Spokes objection to RSO/17/13

Leith Street, Calton Road, Greenside Row, Waterloo Place

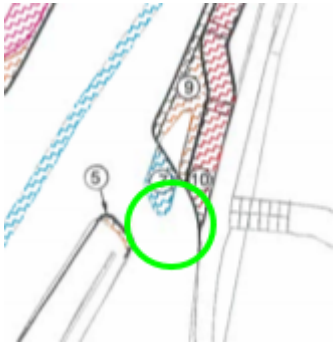
It seems clear from the layout of the southern terminus of the cycleway at Calton Road that cyclists can only rejoin the carriageway onto Calton Road, and not Leith Street. We therefore assume that cyclists wishing to continue up Leith Street to the East End junction will need to use the small section of cycleway just north of the Greenside Row crossing that looks like it will permit rejoining the southbound carriageway (see diagram, left).

We are concerned that this forces cyclists to make a dangerous maneuver by merging into traffic without room to do so. Inspection of the plans suggests that there is width to accommodate 5 lanes for general traffic at this point and we suggest that this is reduced to 4 lanes so that space can be reallocated to provide a safe zone for merging, as described in *Cycling by Design* §6.2.6 and as used in the recently opened cycleways on Leith Walk.
